Access Compliance Report

Public Rights-of-Way

(Curb Ramps)

Intersection ID: 30677	Main Street: DIXIE_HILLS_DR	Cross Street: MARVIN_RD	Location:	N
ADA ID: C2958F3C1436	Ramp Type: BlendTrans2	Initial Pass/Fail: Fail	Overall Compliance: No	Severity Score: 12.5
Codes/Mitigation Info/Possible Solution		Field Measurements/Component Compliance

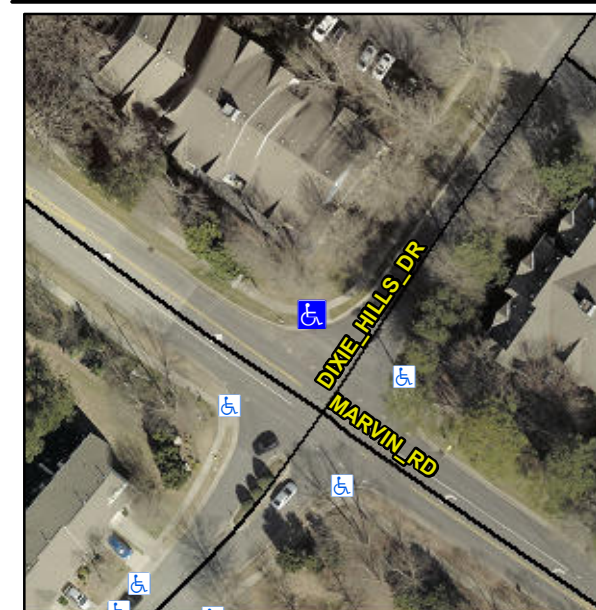
Not Found, R304.5.3

Compliance	Description	Data	Compliance	Description	Data
N/A	Ramp Length (in)	114.0	Yes	BlendTrans Slope (%)	3.5
Yes	Ramp Width (in)	56.0	No	BlendTrans XSlope (%)	6.1
N/A	Flare Type LT	N/A	N/A	Flare Type RT	N/A
N/A	Flare Slope LT (%)	N/A	N/A	Flare Slope RT (%)	N/A
N/A	Flare Traversable LT?	N/A	N/A	Flare Traversable RT?	N/A
N/A	Landing Length (in)	N/A	N/A	DWS Provided?	N/A
N/A	Landing Width (in)	N/A	N/A	DWS Contrast?	N/A
N/A	Landing Slope (%)	N/A	N/A	DWS Length (in)	N/A
N/A	Landing X Slope (%)	N/A	N/A	DWS Full Width?	N/A
N/A	Landing Curb? (Y/N)	N/A	N/A	DWS Offset (in)	N/A
N/A	Shared Landing?	N/A			
N/A	Gutter Ponding?	N/A	N/A	Gutter Slope (%)	N/A
N/A	Gutter Lip Ht (in)	N/A	N/A	Gutter X Slope (%)	N/A
N/A	Painted X Walk1?	No	N/A	Painted X Walk2?	No
	X Walk 1 Direction	To SW		X Walk 2 Direction	To SE
	X Walk 1 Width (in)	N/A		X Walk 2 Width (in)	N/A
	X Walk 1 Slope (%)	0.0		X Walk 2 Slope (%)	7.7
	X Walk 1 X Slope (%)	8.2		X Walk 2 X Slope (%)	0.6

Remove & Replace Curb Ramp With Two New Directional Ramps or Equivalent.
